Building Code of Australia 2019 Amendment 1 & DDA Premises Standards Review (Accessibility Report)

Application for DA2

417 Rosehill Road, Blakebrook NSW – Blakebrook Public School

Our Ref: 23000418 | Issue date: 18-Dec-2023

RAISED LEVEL FLOOR PLAN

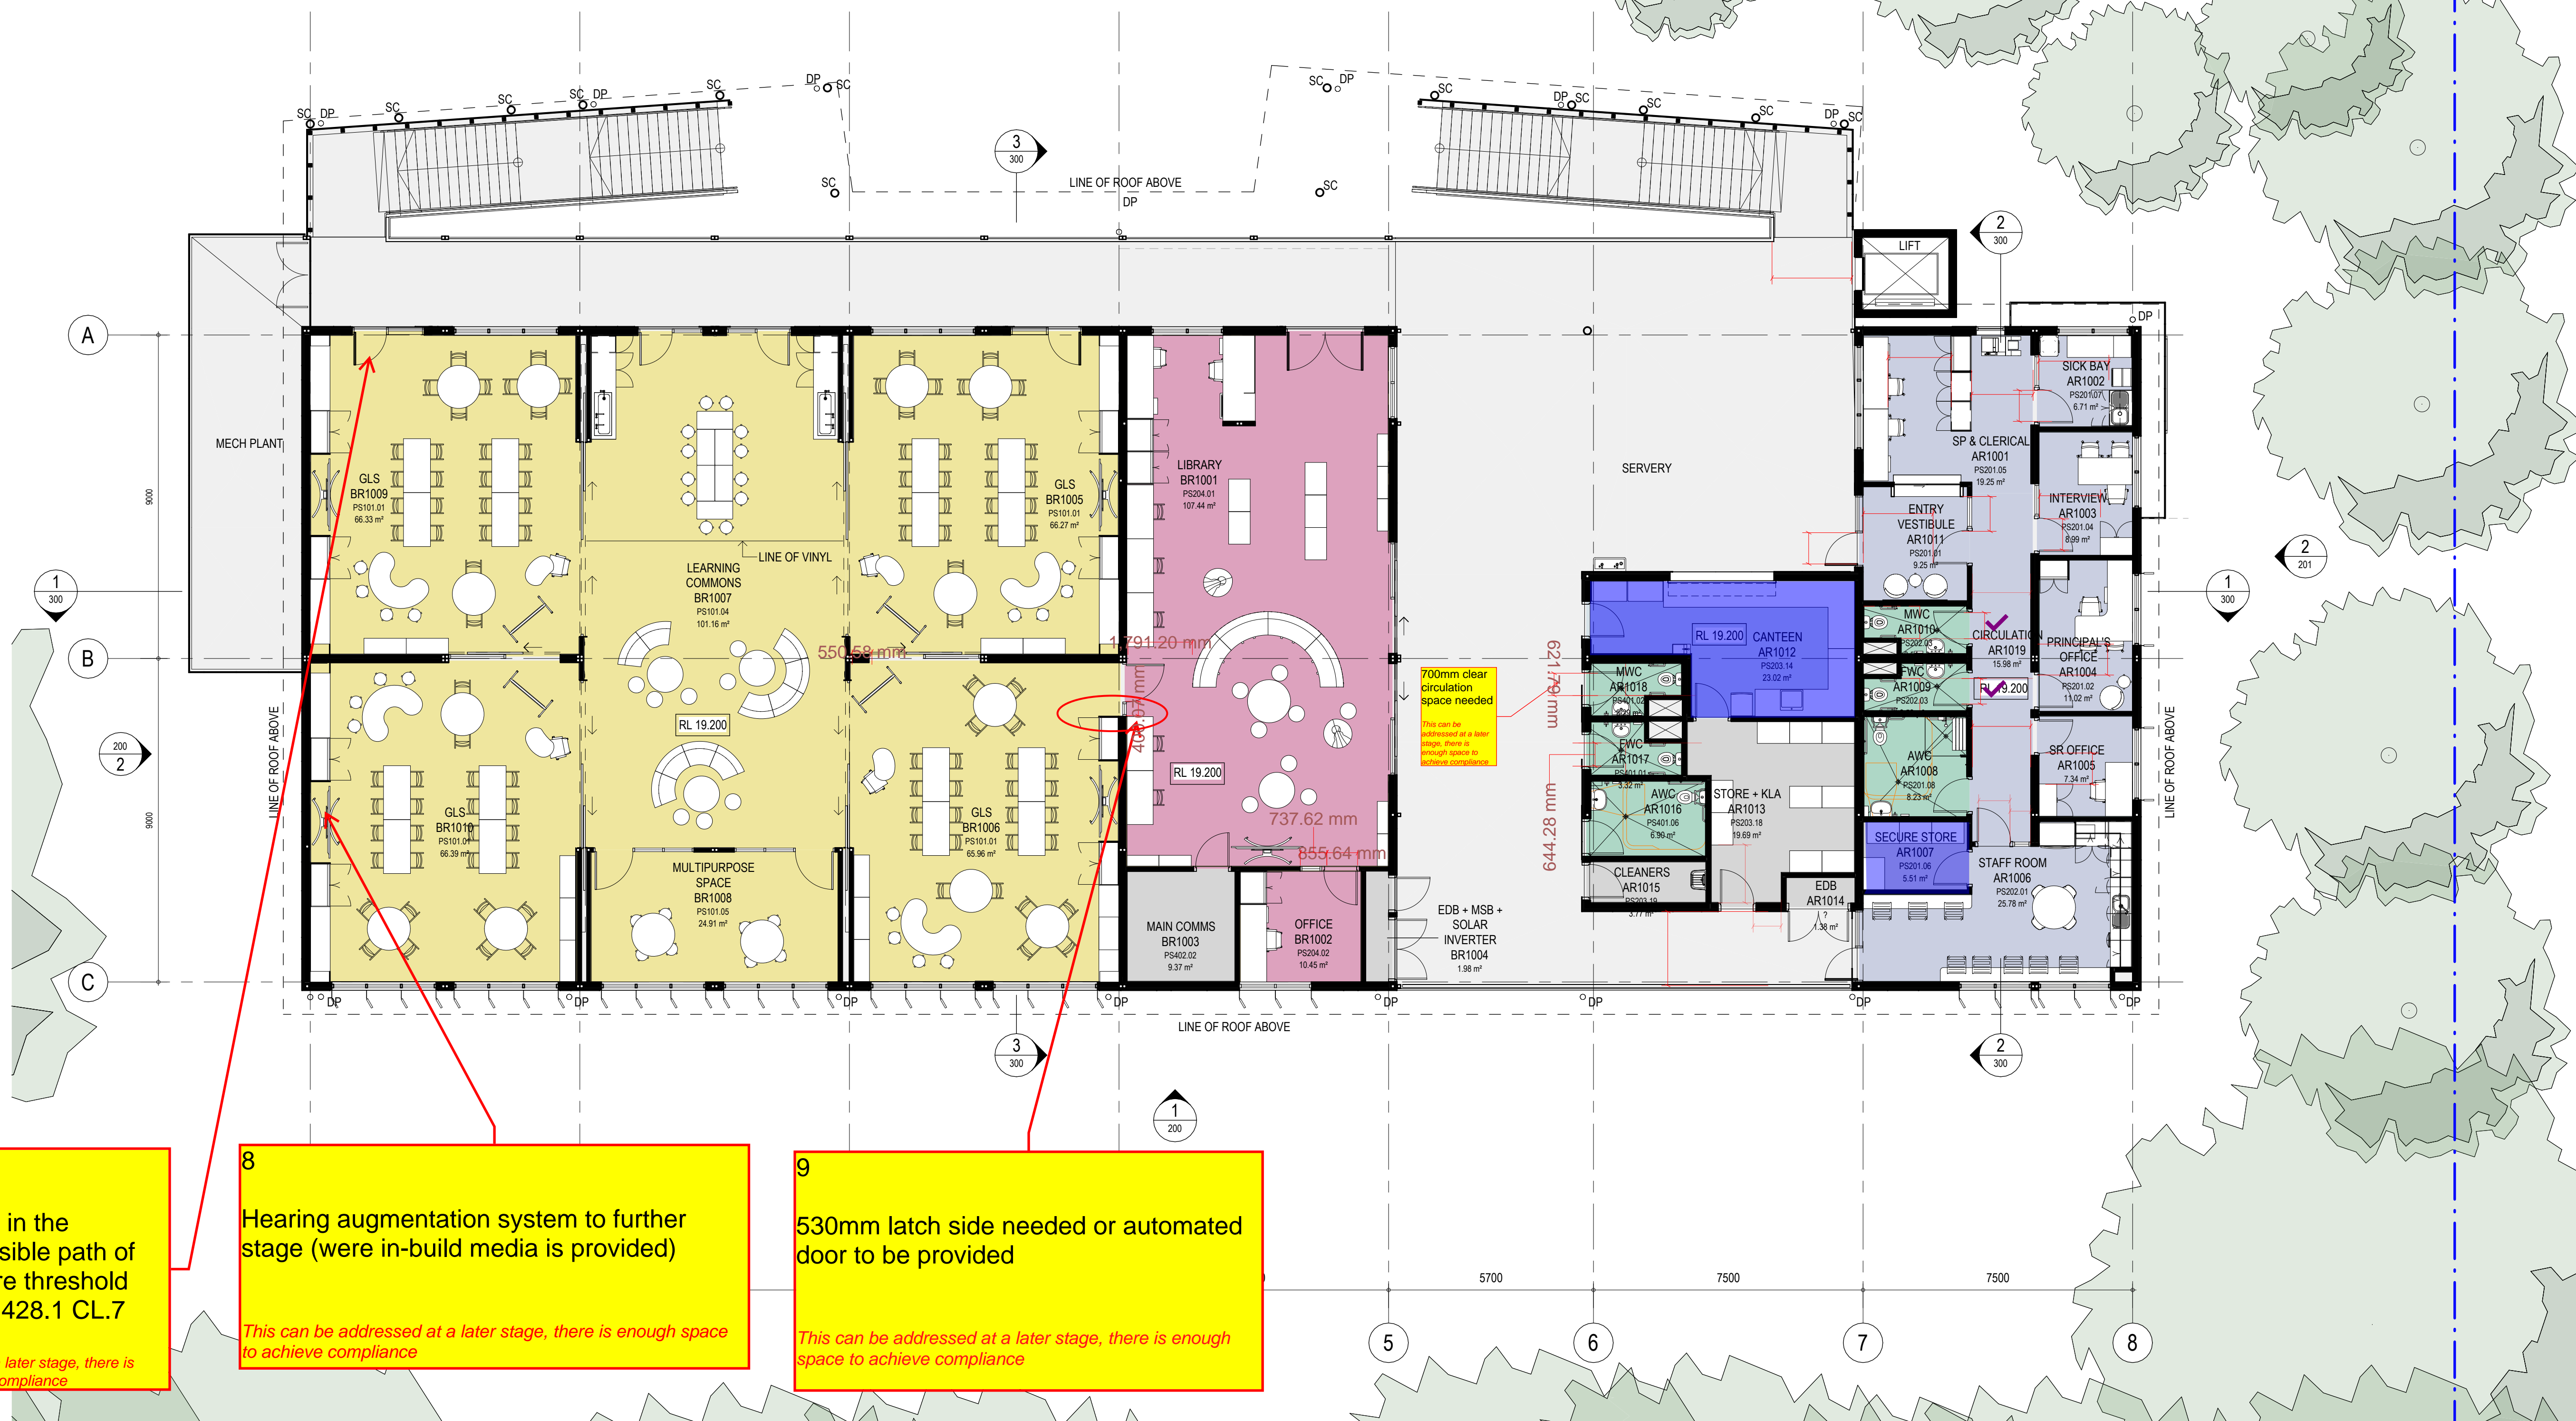
Ensure all doors in the continuous accessible path of travel is to ensure threshold level as per AS1428.1 CL.7

Hearing augmentation system to further stage (were in-build media is provided)

530mm latch side needed or automated door to be provided

This can be addressed at a later stage, there is enough space to achieve compliance

This can be addressed at a later stage, there is enough space to achieve compliance

This can be addressed at a later stage, there is enough space to achieve compliance
